IN THE UNITED STATES PATENT AND TRADEMARK OFFICE (Case No.: RA001C13)

In the Application of:					
FARMWALD ET AL.)				
Serial No: Continuation of 09/835,263)				
Filed: Herewith)				
Title: SYNCHRONOUS INTEGRATED CIRCUIT DEVICE (As Amended))

PRELIMINARY AMENDMENT

REQUEST TO APPROVE DRAWING CHANGES

FIG. 10

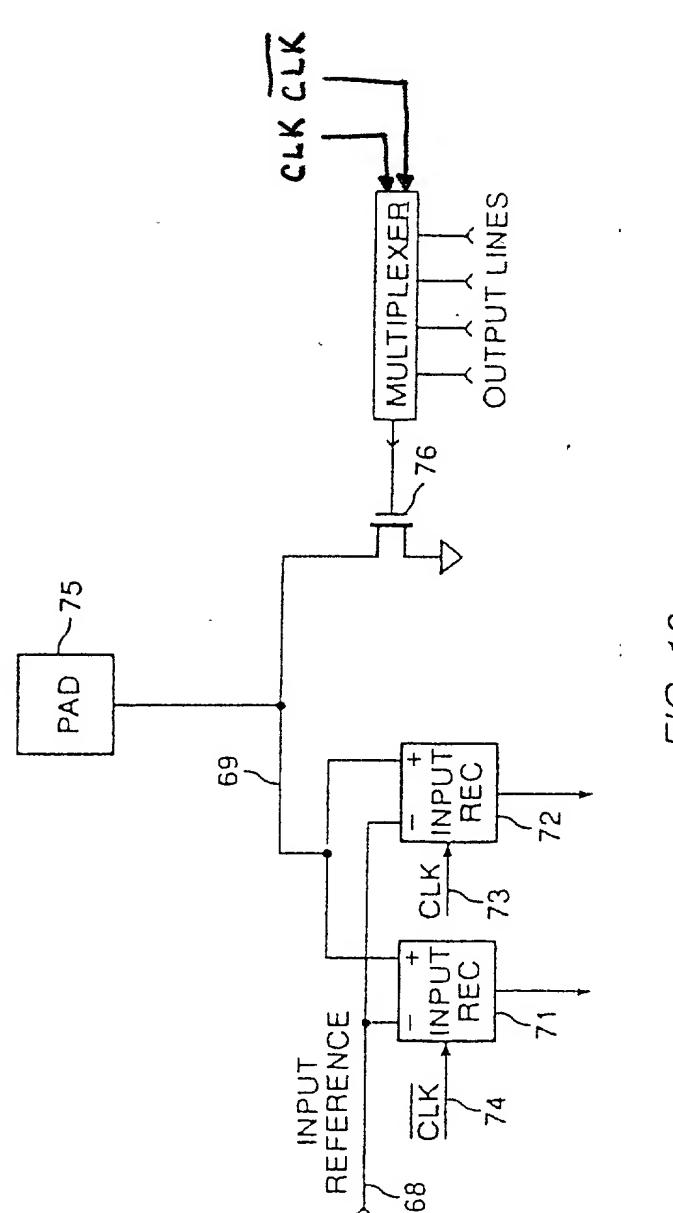
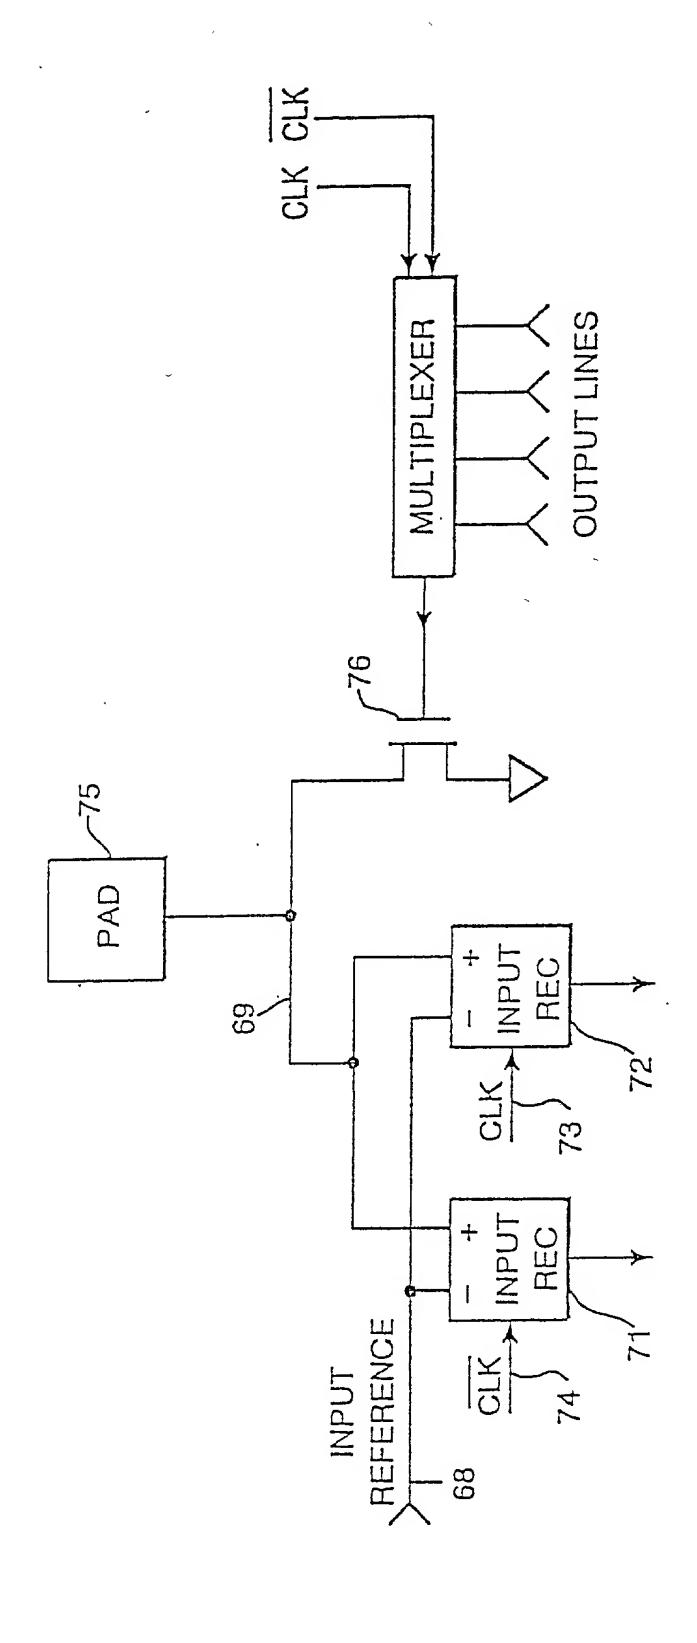
Accompanying this Preliminary Amendment is a Request to Approve Drawing Changes. Applicants seek to amend Figure 10 to more fully reflect the discussion in the specification, in particular, page 55, lines 12-16 and page 58, lines 13-23. The proposed changes are indicated in red. No new matter has been added. Applicants respectfully request that the Examiner approve the proposed changes to Figure 10. A new Figure 10 which incorporates the changes is also attached to the Request.

Applicants seek to amend Figure 10 to more fully reflect the discussion in the specification, specifically, page 55, line 12-16 and page 58, lines 13-23. Also attached, is a photocopy of Figure 10 with the proposed changes indicated in red. No new matter has been added.

Applicants seek to amend Figure 10 to more fully reflect the discussion in the specification, specifically, page 55, line 12-16 and page 58, lines 13-23. Also attached, is a photocopy of Figure 10 with the proposed changes indicated in red. No new matter has been added.

Applicants respectfully request approval of the proposed changes to Figure 10. A new Figure 10 which incorporates the changes is also attached hereto.

Applicants respectfully request approval of the proposed changes to Figure 10. A new Figure 10 which incorporates the changes is also attached hereto.
